SITE PLAN REVIEW

Location: 1928 1/2 Grand Ave.

Project Name: Duplex

TITLE HEADING: Site Plan Review - Duplex

28 1/2 GRAND AVE.
 RYLAND SUB.
 -1
 DT-19

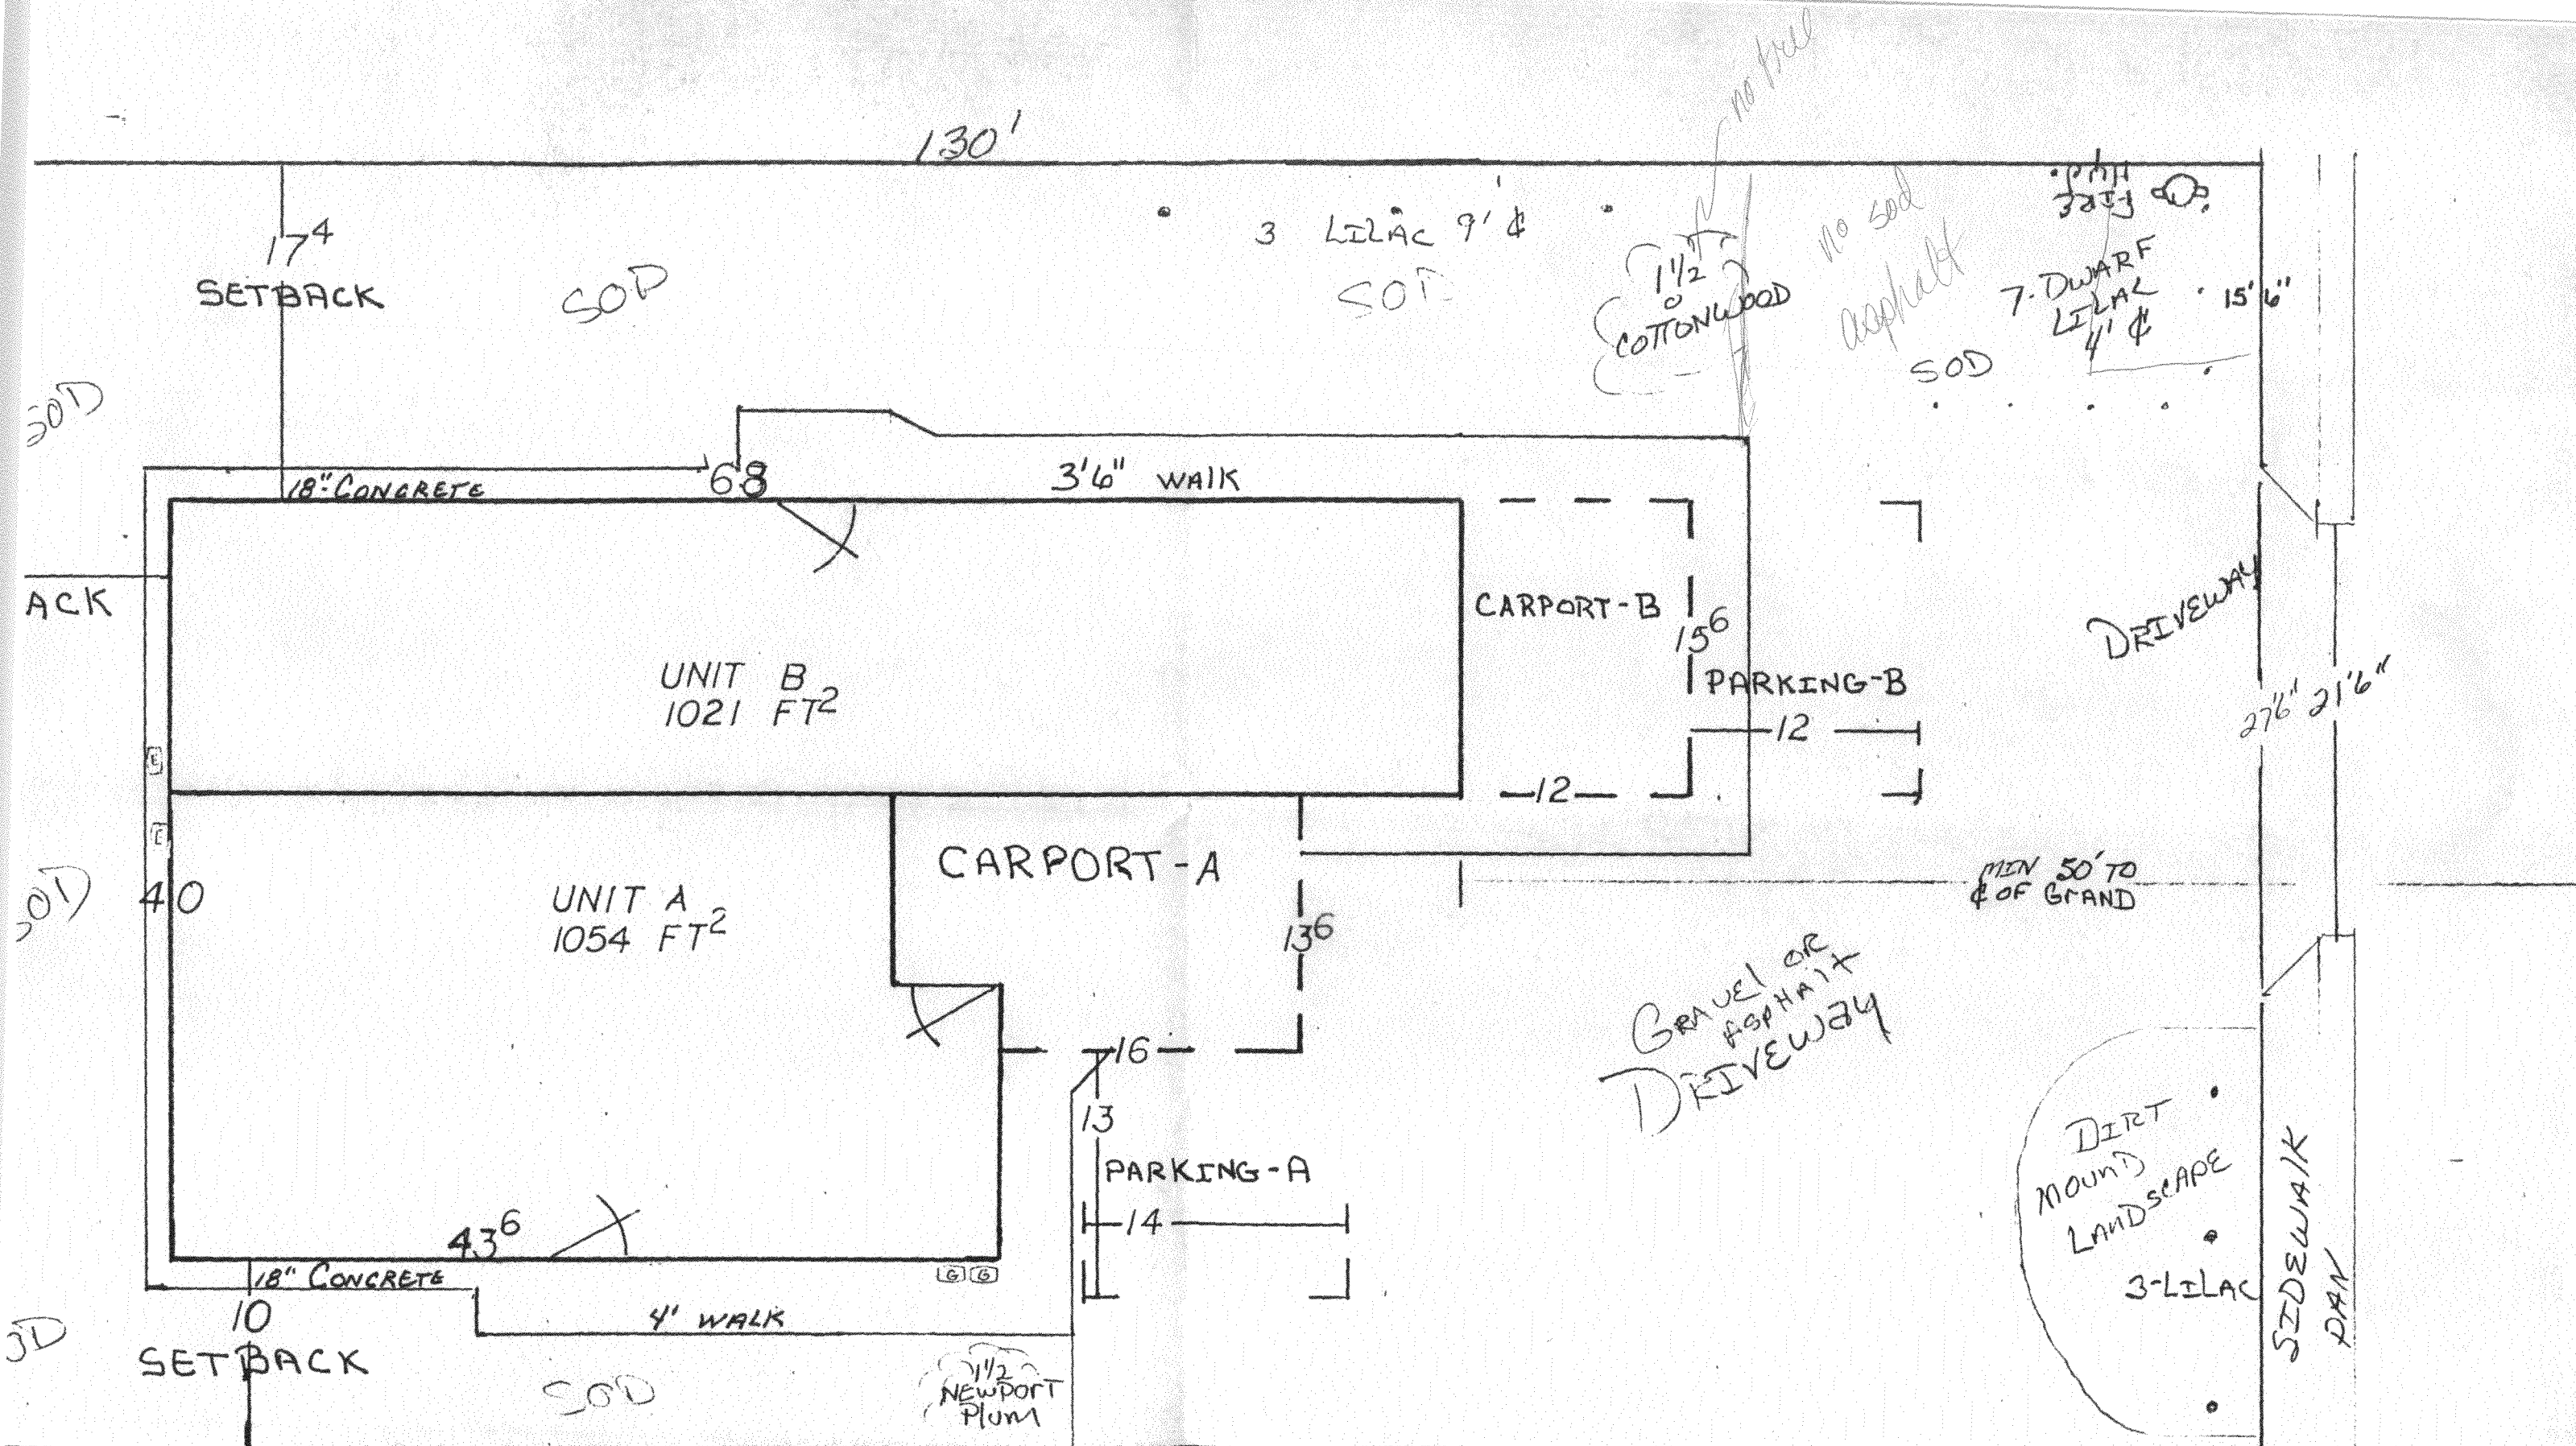
Need easement if both driveways are intended for use by residents of all units.

If the driveway is meant to be a circular drive with the property to the west, an easement must be provided.

DRIVEWAY: HAD NO
PLANS FOR EASEMENT
AGREEMENT ON
1928 & 1928 1/2
GRAND AVE. PROPERTIES.
1928 IS BUILD AND
SHOWS NO SIGNS OF
NEEDING ANY MORE
ROOM THAN SINGLE LOT
HAS FOR ACCESS OR EGRESS,
WITH NO REASON TO BE-
LIEVE 1928 1/2 WILL NEED MORE.
